Technical Service Information

FORD CD4E RIGHT HAND DIFFERENTIAL SEAL LEAK

Figure 1

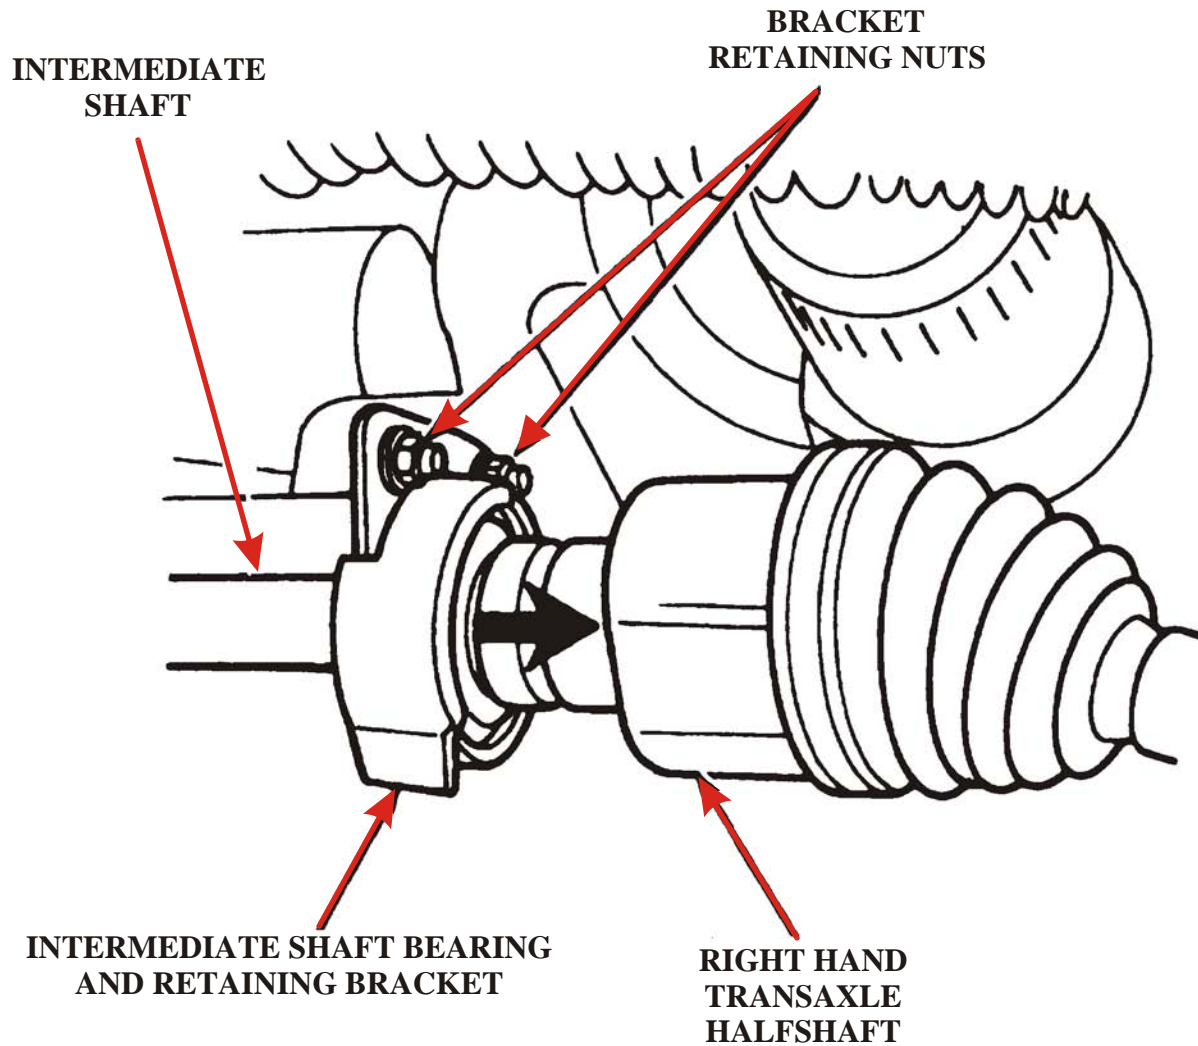
CAUSE: The cause may be, inadvertently using the wrong set of mounting holes when remounting the intermediate shaft bearing and bracket assembly. For location refer to Figure 1. The original 1st design style of intermediate shaft bracket had two sets of mounting holes, one for CD4E applications, and the other set for MTX-75 (Standard Shift) applications, as shown in Figure 2.

Figure 2

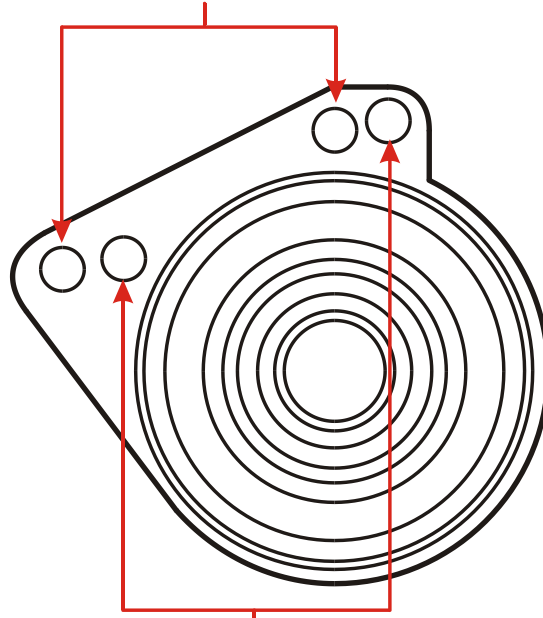
USE THESE TWO HOLES
FOR STANDARD TRANSAXLE

USE THESE TWO HOLES
FOR CD4E TRANSAXLE

CORRECTION: There are now unique support brackets to correct the concern and prevent mis-mounting the bracket in the wrong holes, one support bracket for CD4E applications, and one for MTX-75 applications. Refer to Figure 3. These new style support brackets were used in production during the 1996 model year. The support bracket is serviced as part of the Intermediate Shaft Assembly, and could contain either the 1st design bracket as shown in Figure 2, or the 2nd design bracket as shown in Figure 3. Use care if the 1st design bracket with four holes is supplied to mount it using the proper holes, as shown in Figure 2.
